PONTIAC

Service Craftsman News

No. 5 S-283

May, 1956

Fig. 1 Transmission Rear Throttle Rod and Outer Throttle Lever - Dual Range

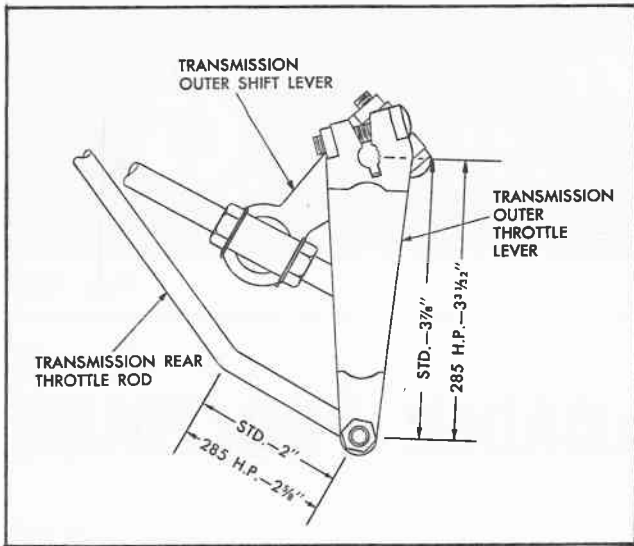
A new outer throttle lever and transmission rear throttle rod have been released for use with the 285 horsepower engine on both Dual Range and Strato-Flight Hydra-Matics.

The new parts provide more TV pressure at low speeds to reduce the tendency of bunching the 1-2 and 2-3 shifts. The increase in TV pressure also improves the 2-3 shift in both transmissions.

Dual Range Hydra-Matic Transmission -- The transmission rear throttle rod designed for use with the 285 horsepower engine has a 2-5/8" length from the center of the rear ball stud to the first bend while the rod used with the standard engine has a 2" length at this location (Fig. 1).

The transmission outer throttle lever for use with the 285 horsepower engine is 3-31/32" long from centerline of throttle shaft hole to centerline of hole for throttle rod ball stud. The lever for use with the standard engine is 3-7/8" long in the same area (Fig. 1).

Whenever a car with the 285 horsepower engine is encountered which has bunched shifts (1-2 and 2-3 too close together) or a poor 2-3 shift, check to see that the new parts have been installed. If not, replace the transmission rear throttle rod and the outer throttle lever with the new type.

The new part numbers are as follows:

Dual Range	Strato-Flight
Transmission rear throttle rod	522992	522789
Transmission outer throttle lever	522229	521523

Fig. 2 Strato-Flight Transmission Rear Throttle Rod

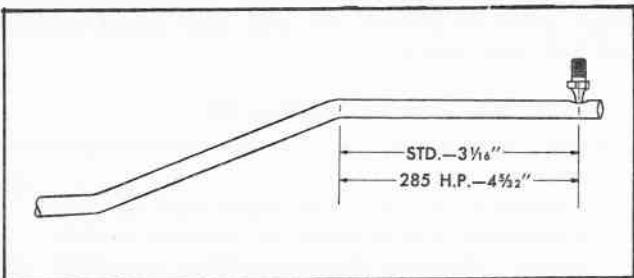
Strato-Flight Hydra-Matic -- The transmission rear throttle rod designed for use with the 285 horsepower engine has a 4-5/32" length from the rear ball stud to the first bend (Fig. 2). The standard rod has a 3-1/16" length at this location.

Fig. 3 Strato-Flight Outer Throttle Levers

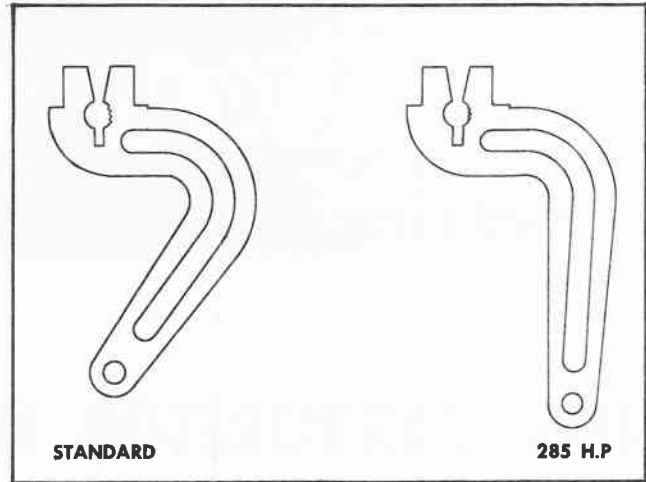
The outer throttle levers have a very obvious difference in shape as shown in Fig. 3.

Fig. 4 Tensioner Spring Installation Drawing

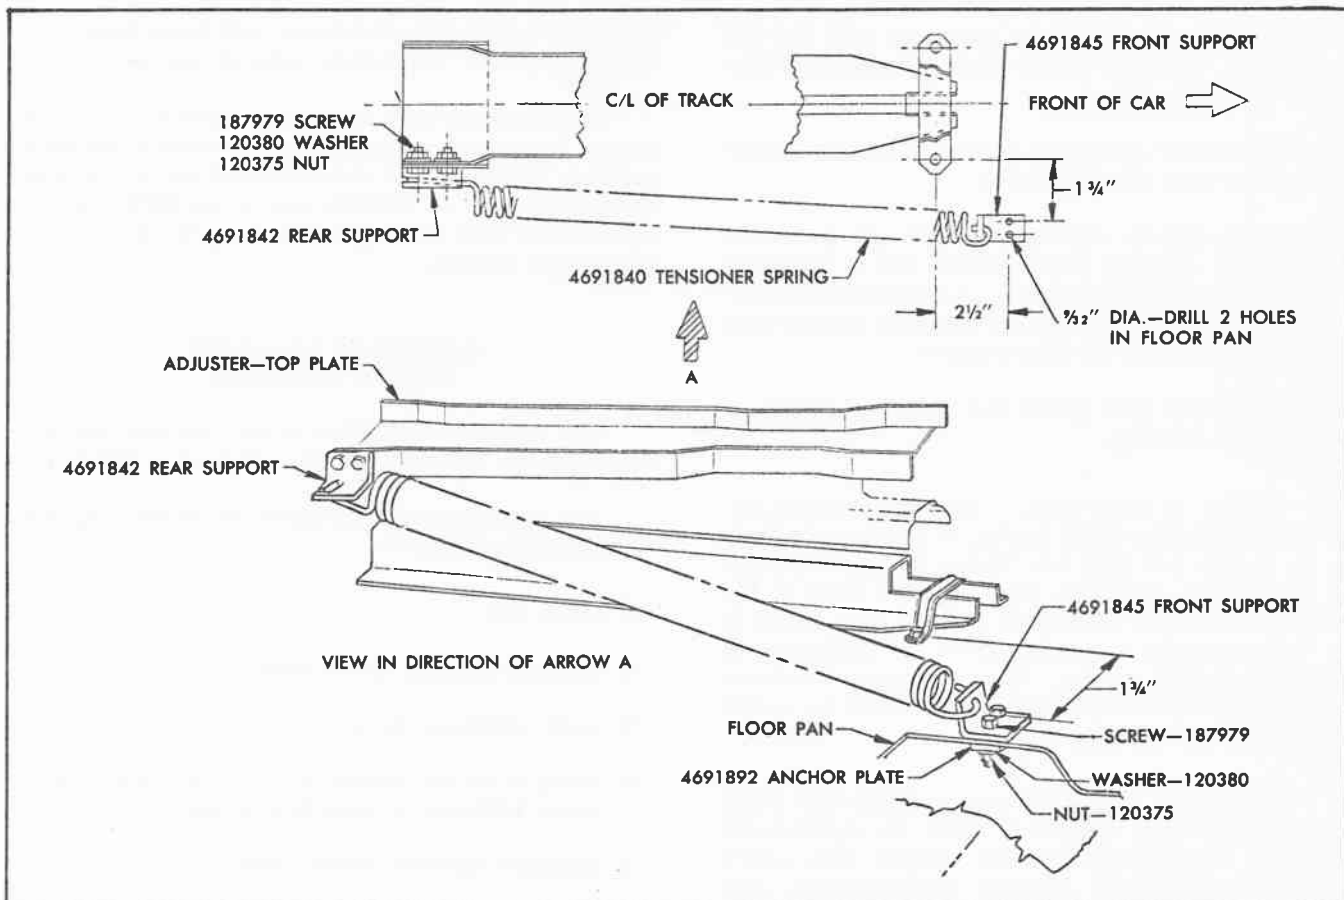
If an excessive seat "chucking" condition is encountered on a power operated six-way seat, the installation of a tensioner spring will effectively reduce the noise and/or "chucking" caused by the movement of the seat adjuster parts at the pivot locations.

1. Operate front seat assembly to the extreme forward position and the rear edge of seat to the extreme upward position.
2. Remove left lower seat side panel; then bend the seat side panel attaching tab downward sufficiently to permit drilling two (2) holes in the top plate as shown in Fig. 4.

3. Locate rear support/flush with the top and rear edge of left seat adjuster top plate, as shown in the drawing; then, clamp support securely to top plate. Using the holes in the rear support as a guide, drill two (2) 9/32 inch diameter holes through seat adjuster top plate; then secure rear support to seat adjuster top plate with two (2) screws, washers and nuts. Bend seat side panel rear attaching tab to original location.

4. Operate seat rearward, rear edge downward and front edge to the extreme upward position; then turn back front floor covering to expose floor pan at tensioner spring front support attaching location. See Fig. 4.

5. Drill two (2) 9/32 inch diameter holes in floor pan at the locations indicated in the drawing; then

secure front support to floor pan with two (2) screws, washers, anchor plate and attaching nuts as shown in Fig. 4.

6. Check and if necessary tighten all seat adjuster to floor pan attaching bolts.
7. Operate seat to extreme forward and downward position. Engage short hooked end of tensioner spring on the front support as shown in the drawing; then with suitable tool carefully engage rear end of spring on the rear support.
8. Install seat side panel and position carpet to original location.
